METROPOLITAN GOVERNMENT OF NASHVILLE AND DAVIDSON COUNTY

STAFF RECOMMENDATION
0000 24th Avenue South (address unknown at this time)
October 17, 2012

Application: New construction - infill
District: Hillsboro-West End Neighborhood Conservation Zoning Overlay
Council District: 18
Map and Parcel Number:
Applicant: Michael Ward, Allard Ward Architects, LLC
Project Lead: Robin Zeigler, Robin.Zeigler@nashville.gov

Proposed Site Plan

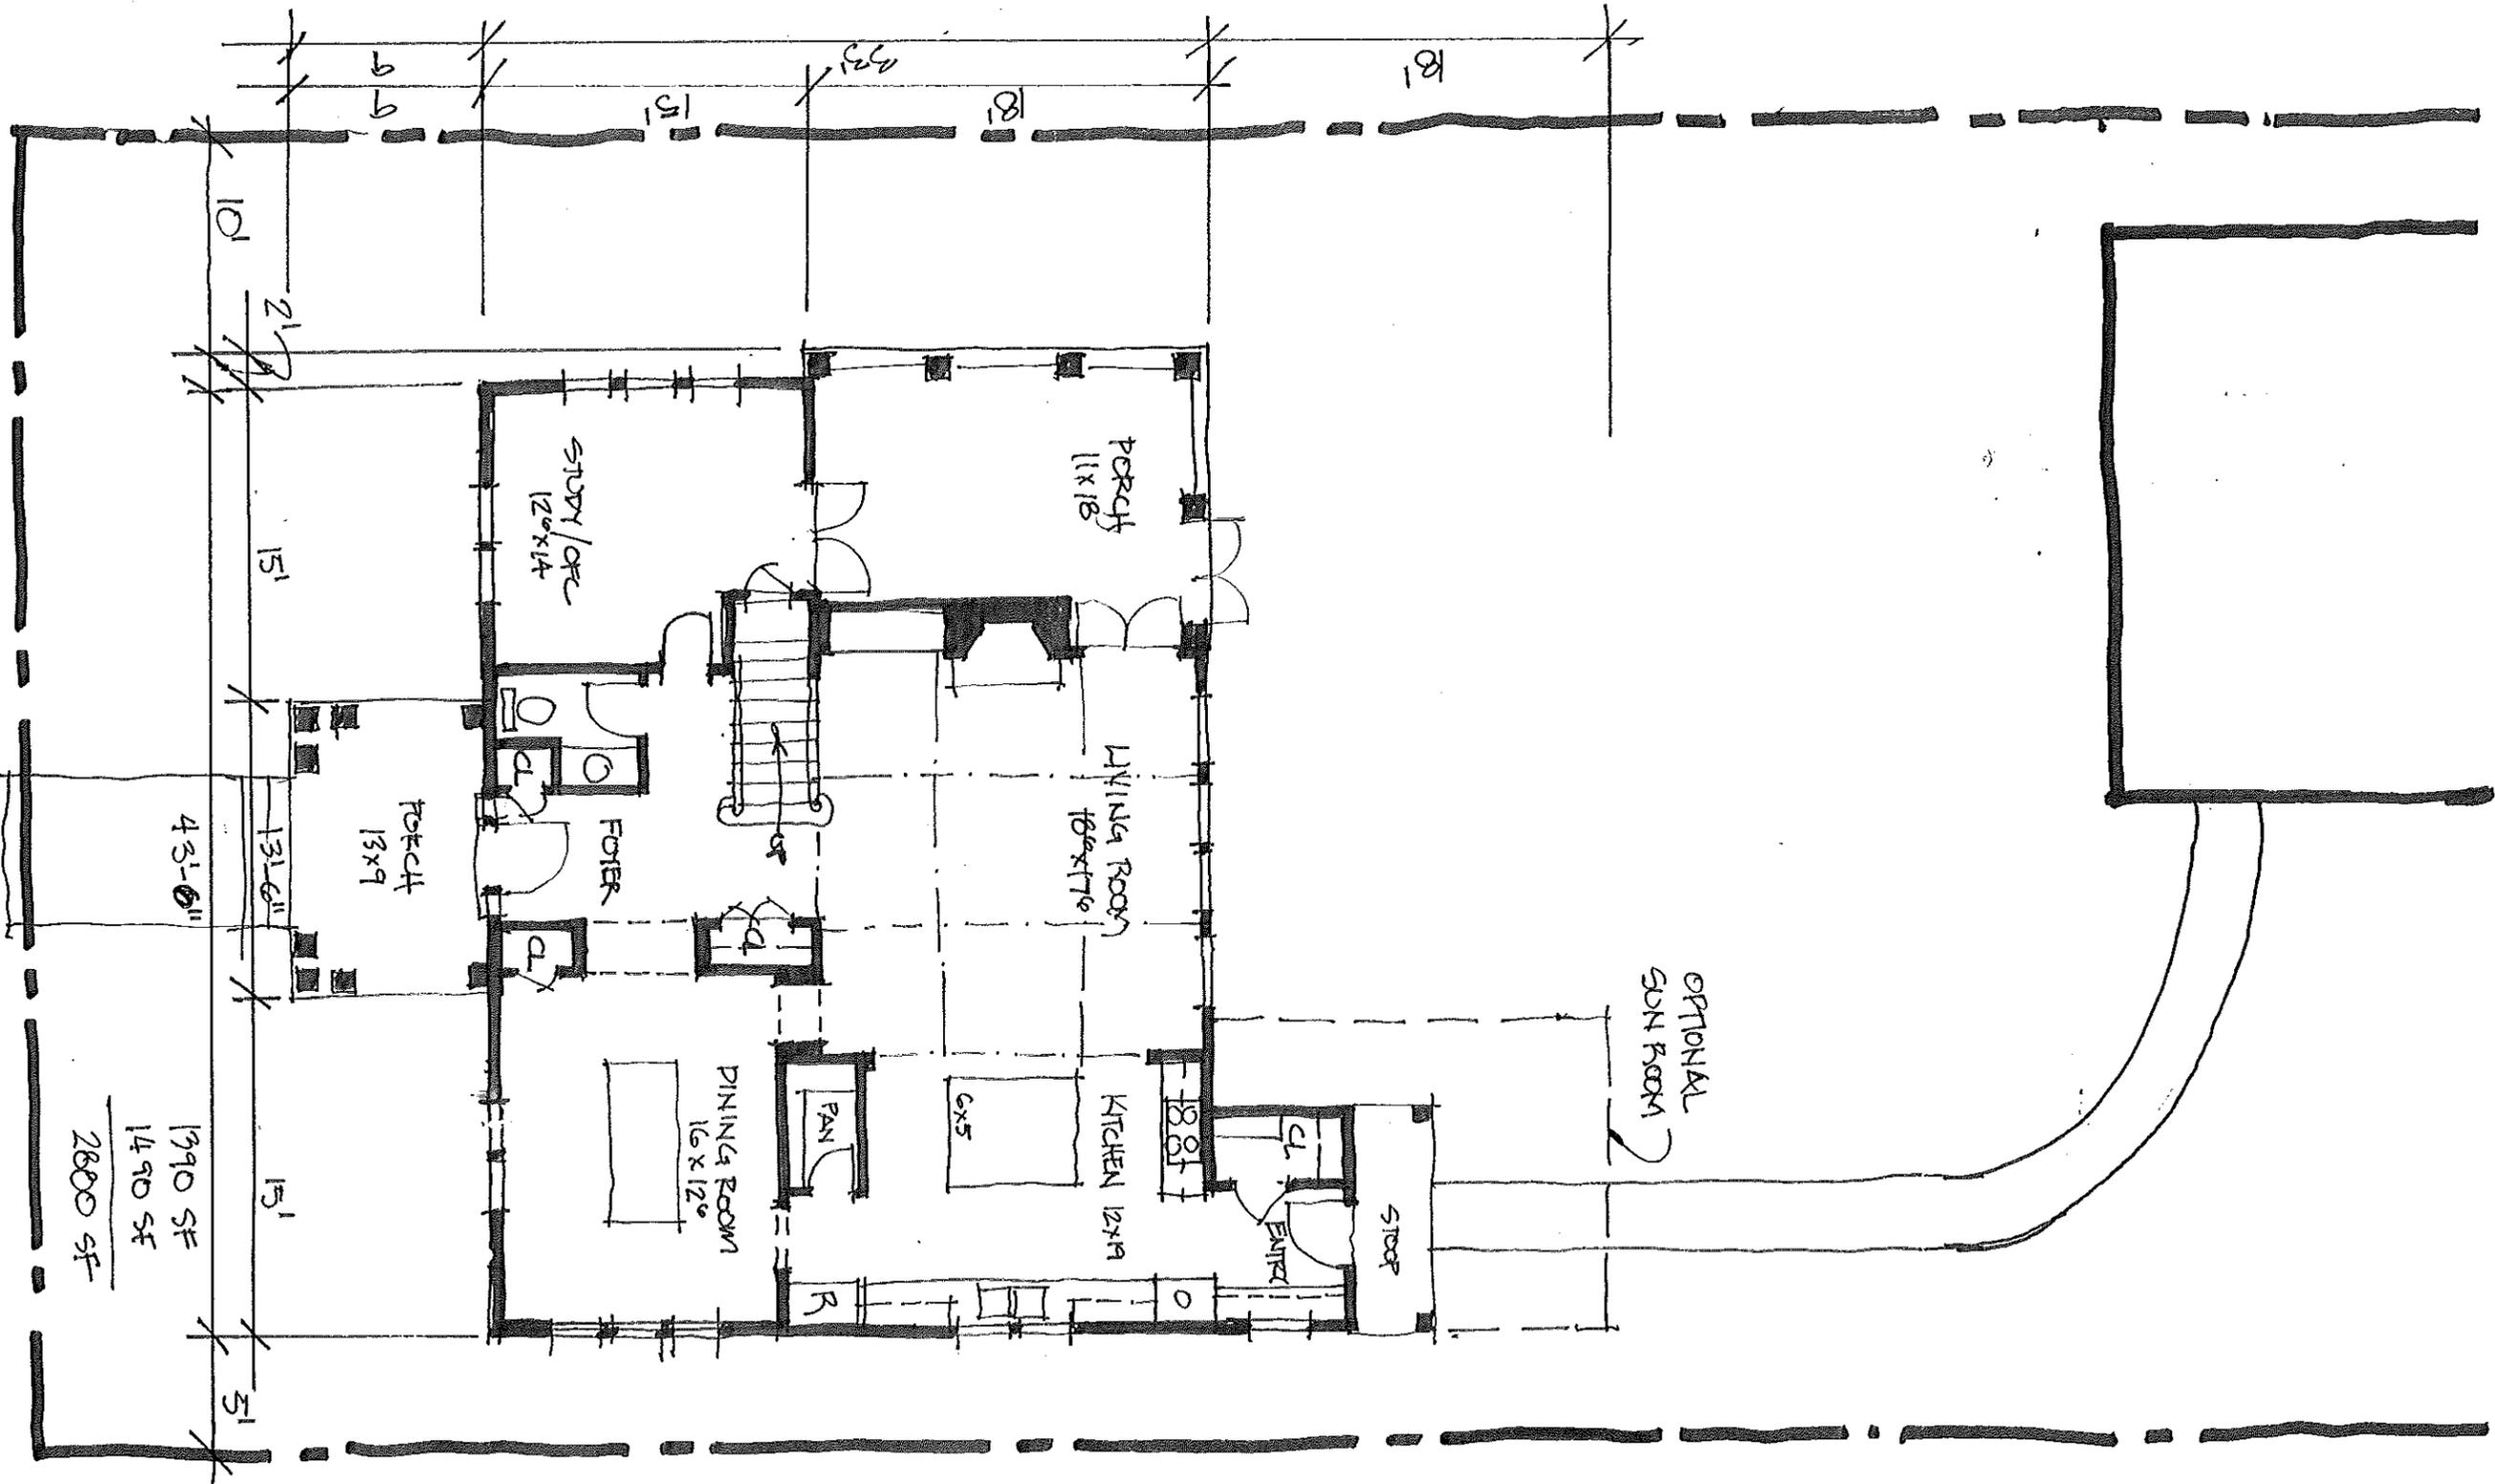
Setback and Rhythm of Spacing: The front setback including the narrow porch is approximately twelve feet (12') and the bulk of the house sits back twenty feet (20'). The side setback for the nearest home facing Barton Avenue is approximately fifteen feet (15'). Buildings do not face 24th until the next southern block of 24th Avenue South. Staff found the twelve/twenty foot (12'/20') setback to be appropriate for this section of 24th Avenue South as there is no immediate context for homes on 24th and the proposed setback is within the range of setbacks in the vicinity. Side setbacks are approximately ten feet (10') on the left (alley side) and five feet (5') on the right and the project meets all requirements of bulk zoning. Staff finds the setback and spacing to meet section II.B.c.

Accessory Building: An accessory structure is planned and shown on the site plans but elevations were not submitted as a part of the project.

Drawings:
 East Elevation
 South Elevation
 Date: 10-3-12

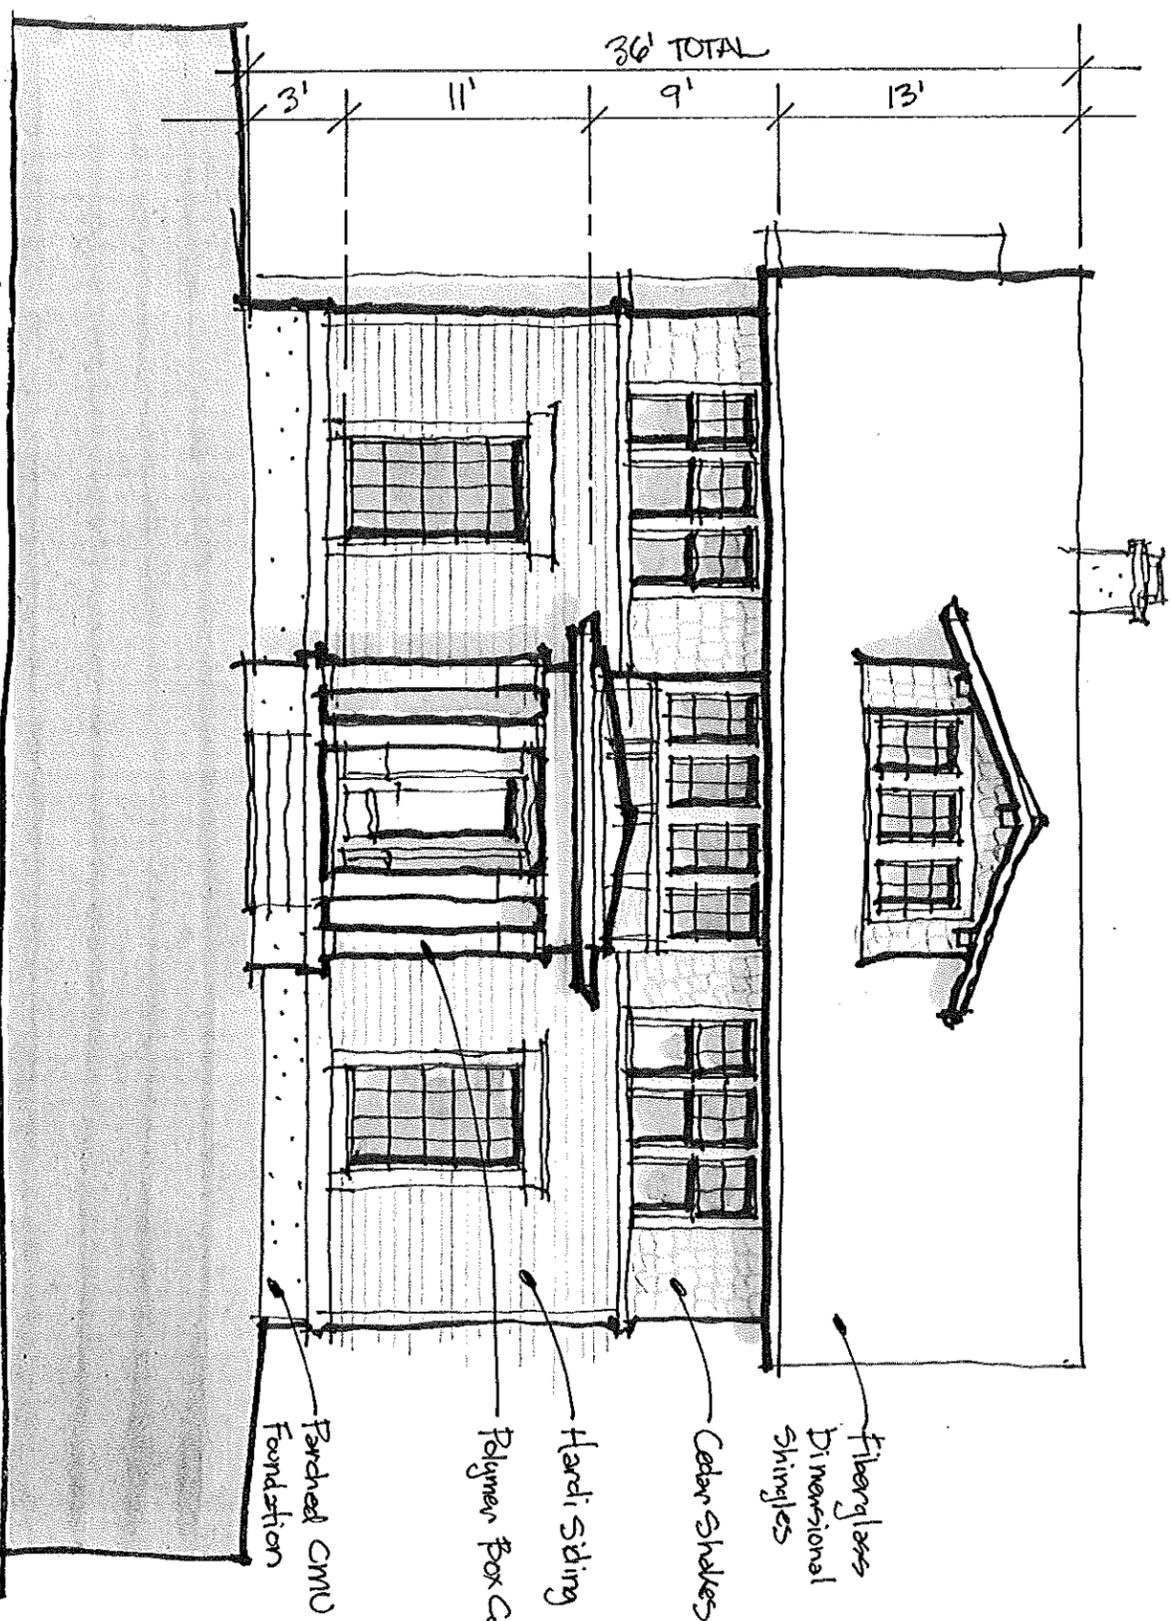
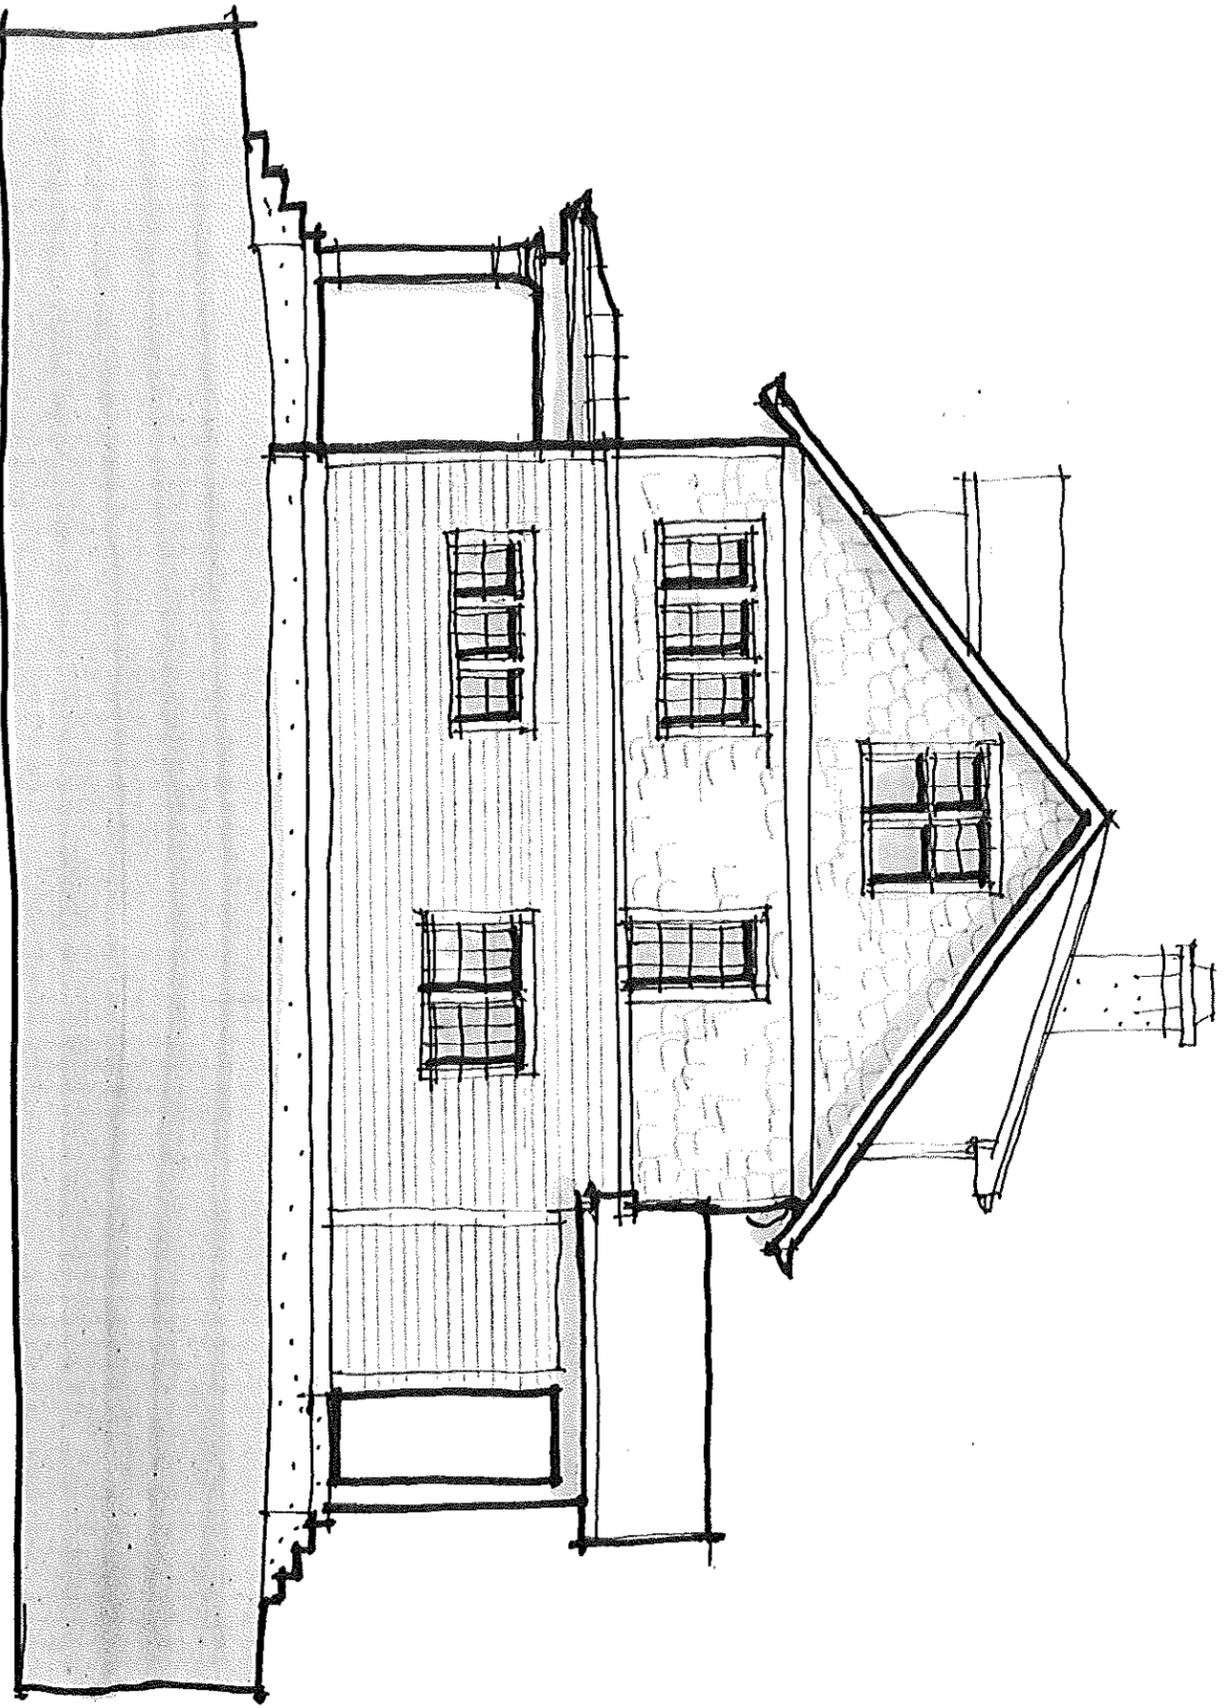
Height & Scale : The majority of homes in the immediate context are one and one-half story buildings that range in height from approximately twenty feet to twenty-six feet (20'-26'). Two-story Four-square homes in immediate vicinity are between thirty-four and thirty six feet (34'-36') tall from grade. The proposed building fits within this range at thirty-six feet (36') from grade to ridge. The foundation height is approximately three feet from existing grade, which is which is similar to other homes in the neighborhood. Staff finds the height to meet section II.B.a.

Materials, Texture, Details, and Material Color: Materials include a parged split-faced CMU block foundation; cement fiber lap siding, shingles and panels; composite trim and posts and a fiberglass shingle roof. The porch is concrete and the chimney stucco. The materials for the doors and windows are unknown. Staff recommends final approval of windows, doors, and roof color. All known materials meet section II.B.d.

Roof Shape: The roof shape is a side-gable with a 12/10 pitch and a central gabled dormer. Both the shape and pitch are found in the neighborhood and so meet section II.B.e.

Proportion and Rhythm of Openings: The majority of windows are twice as tall as they are wide, meeting the ratio of historic windows. The rhythm also meets the historic context with the greatest linear space without an opening being only approximately twelve-feet (12') on a secondary elevation. The project meets section II.B.g.

Staff recommends approval with the condition that staff provide final review of windows, doors, roof color and location of utilities.
